ADDENDUM NUMBER 02 (REVISED)

DATE: January 23, 2024

PROJECT: Cass District Library Edwardsburg, MI

PROJECT NUMBER: 22-1836

10 WATER SERVICE DETAIL  
M8.0 SCALE: NONE

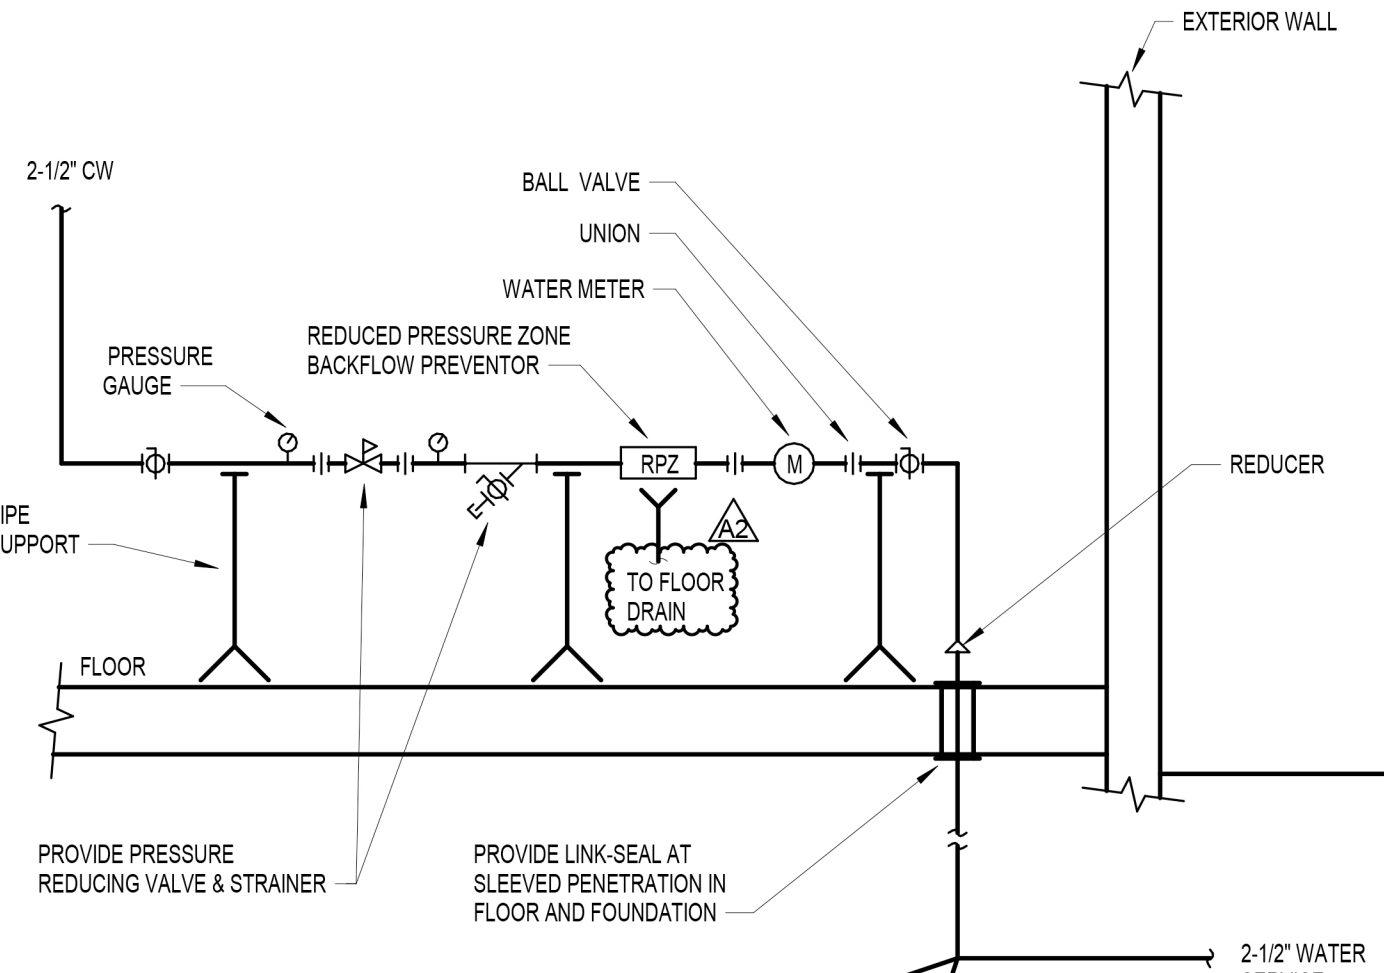
- 69. **REVISE** Condensing Unit Support detail to include a manufactured condenser support pad and note.
- 70. **ADD** Note to Water Service Detail beneath RPZ calling to drain into Floor Drain.
- 71. **REVISE** 3-Way AHU Coil Piping Detail to make sure note leaders point to the correct symbol.
